Access Compliance Report

Public Rights-of-Way (Curb Ramps)

| Intersection ID: 17138 | Main Street: IDLEWILD_RD | Cross Street: PINEY_GROVE_RD | Location: NE |
| ADA ID: 3C49F7EC29A1 | Ramp Type: Para | Initial Pass/Fail: Fail | Overall Compliance: No |

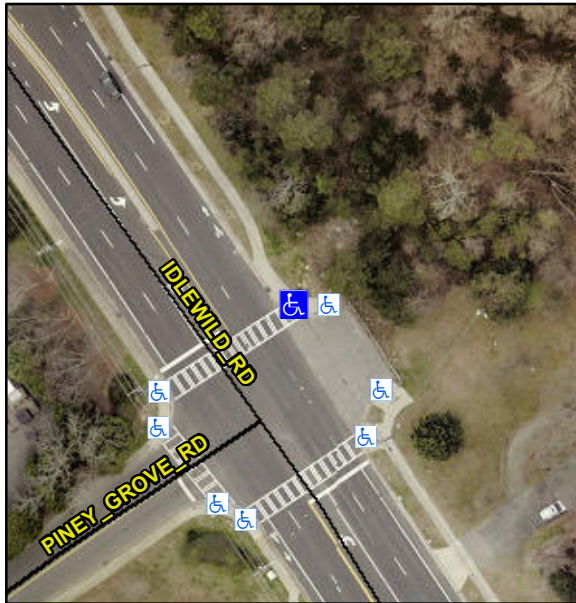
R304.3.2, R304.5.3

| Compliance | Description | Data | Compliance | Description | Data |
|------------|----------------------|-------|------------|-----------------------------|------|
| No | Ramp Slope LT (%) | 8.5 | Yes | Ramp Slope RT (%) | 7.2 |
| No | Ramp XSlope LT (%) | 2.1 | No | Ramp XSlope RT (%) | 3.1 |

Remove & Replace Entire Ramp.
